SITE DEVELOPMENT PLANS FOR  
SLIM CHICKEN'S  
FALCON MARKETPLACE LOT 9  
A PARCEL OF LAND LOCATED IN A PORTION OF THE SOUTHEAST QUARTER OF SECTION 1,  
TOWNSHIP 13 SOUTH, RANGE 65 WEST OF THE SIXTH PRINCIPAL MERIDIAN,  
COUNTY OF EL PASO, STATE OF COLORADO  
PCD FILE #PPR-21-026

SITE DEVELOPMENT PLANS FOR  
**SLIM CHICKEN'S  
FALCON MARKETPLACE LOT 9**

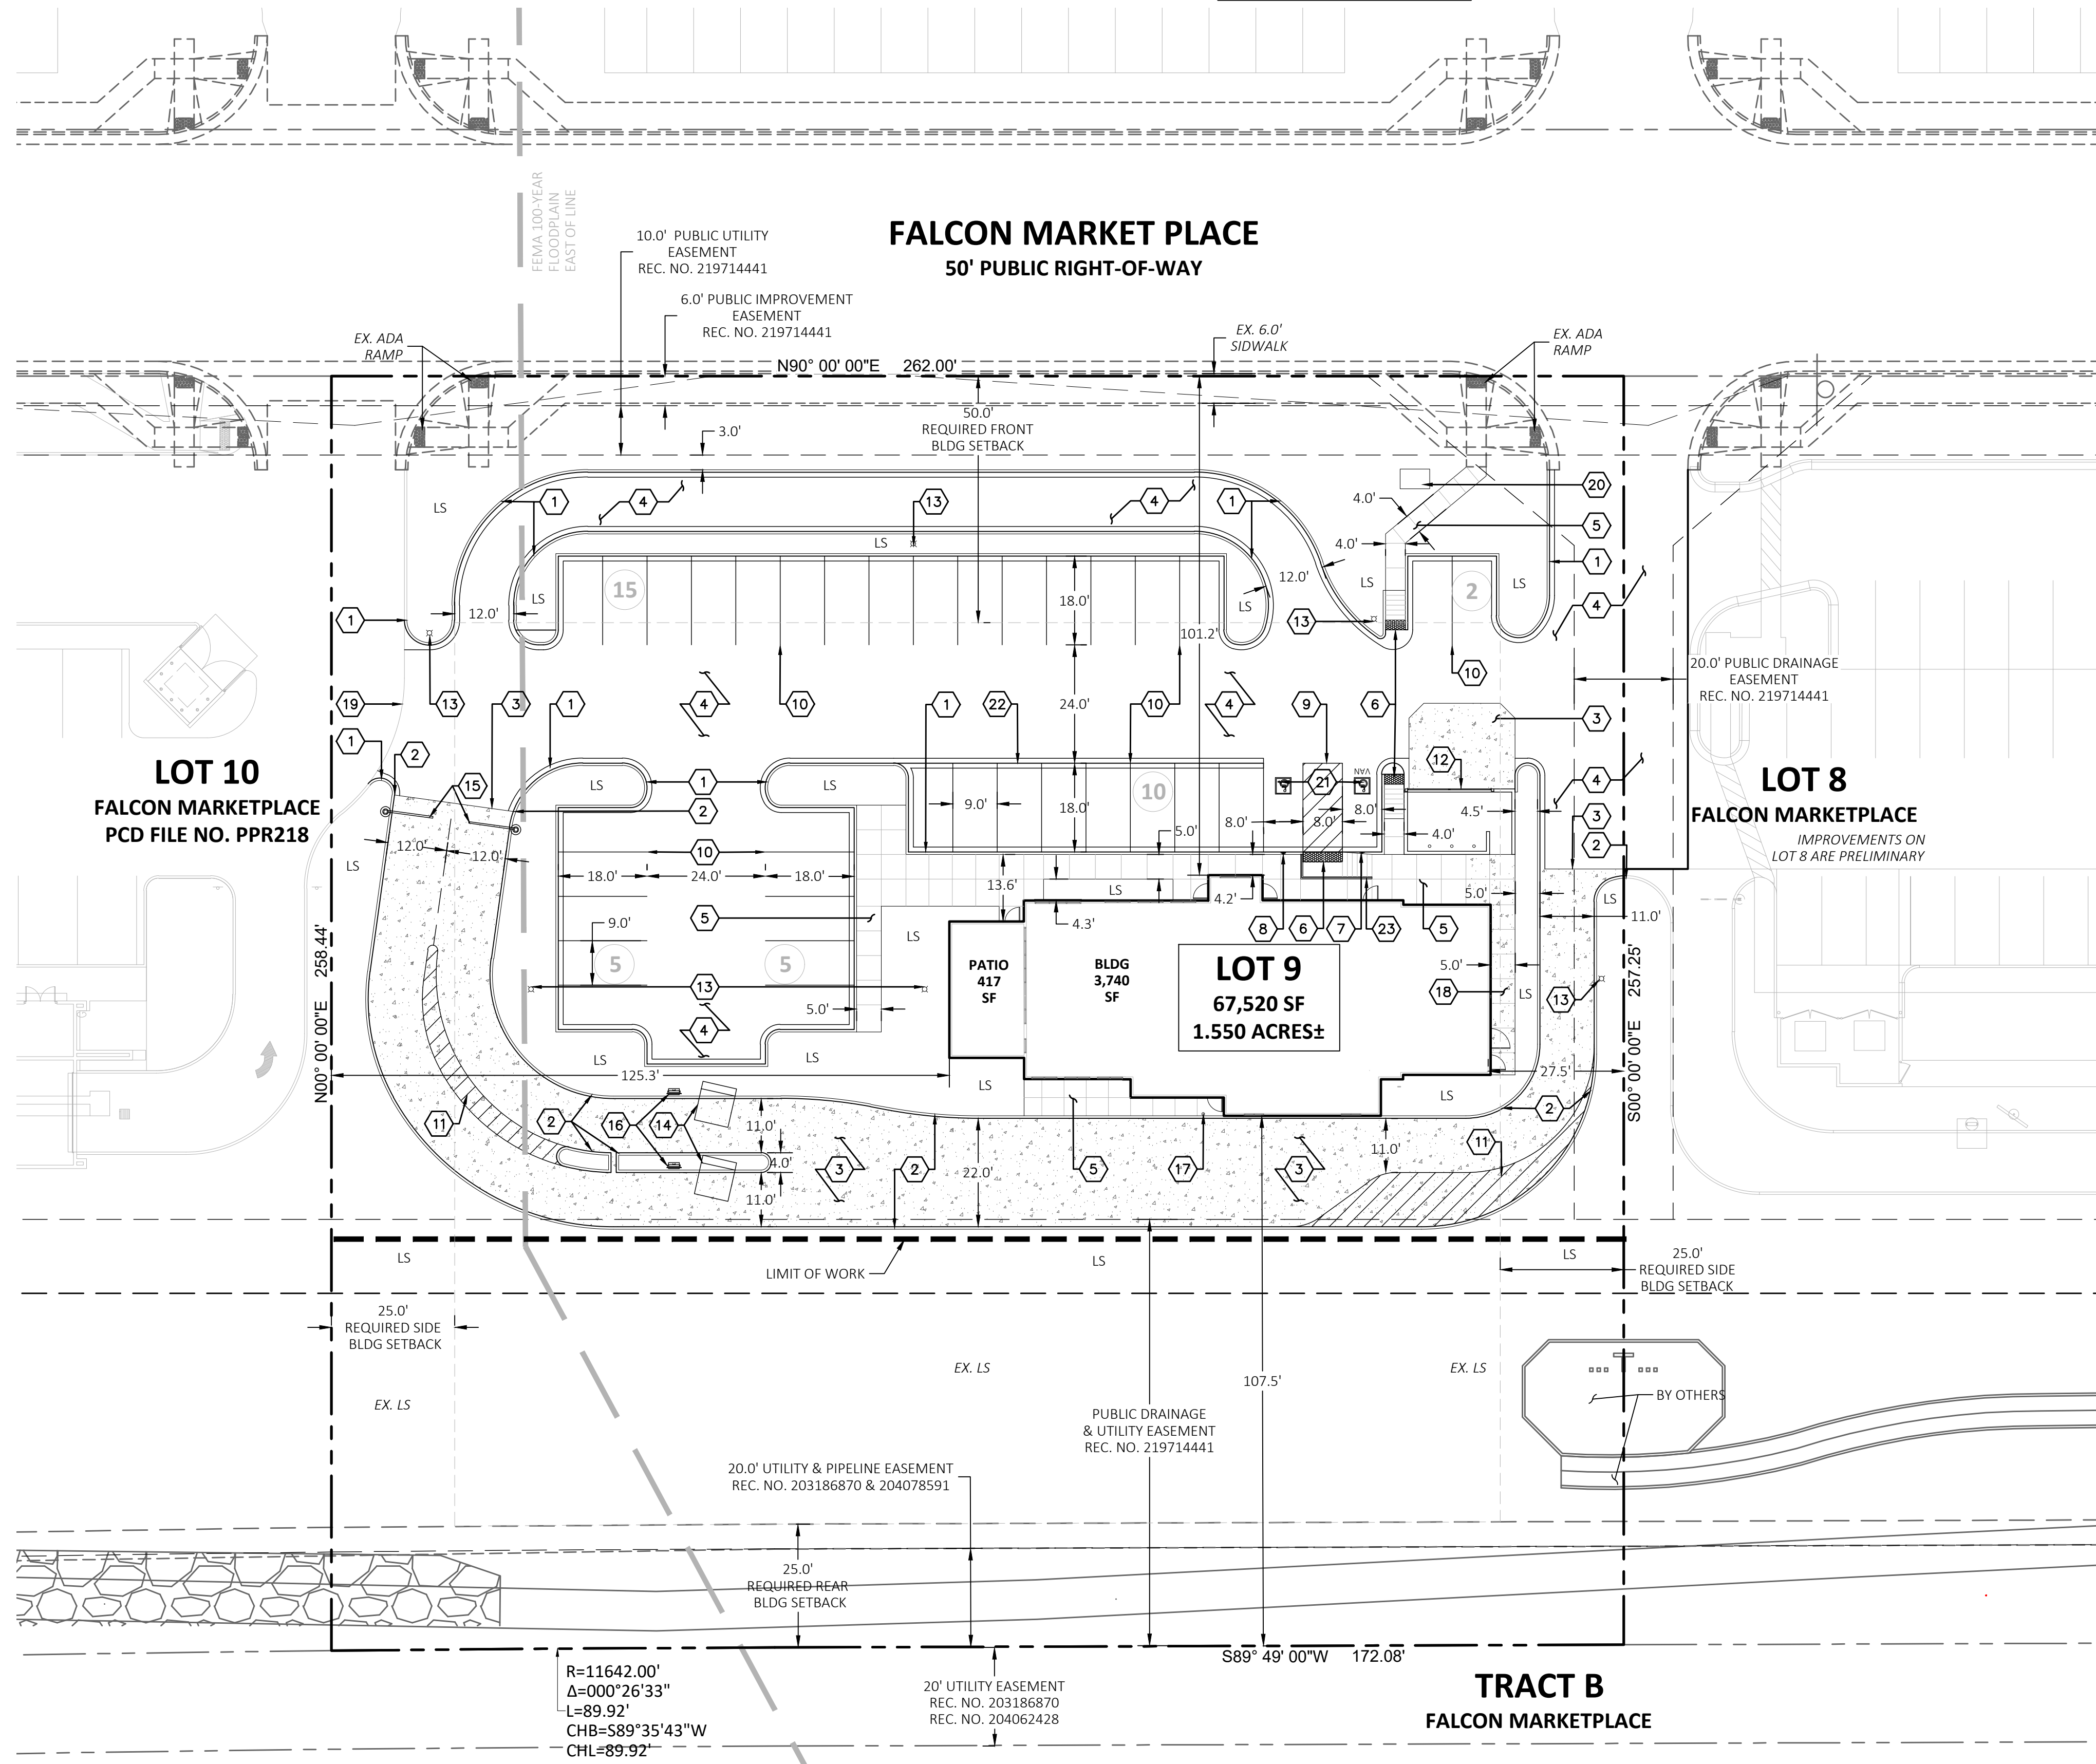
4,023 sq. ft. would result in 40 parking spaces required per LDC Table 6-2 which requires 1 space per 100 sq. ft fast food drive thru use.

Please ensure proper counting for parking spaces. I counted 39 spaces, including the ADA spaces. ADA spaces can count toward total number. You need 40 spaces to meet the LDC requirements.
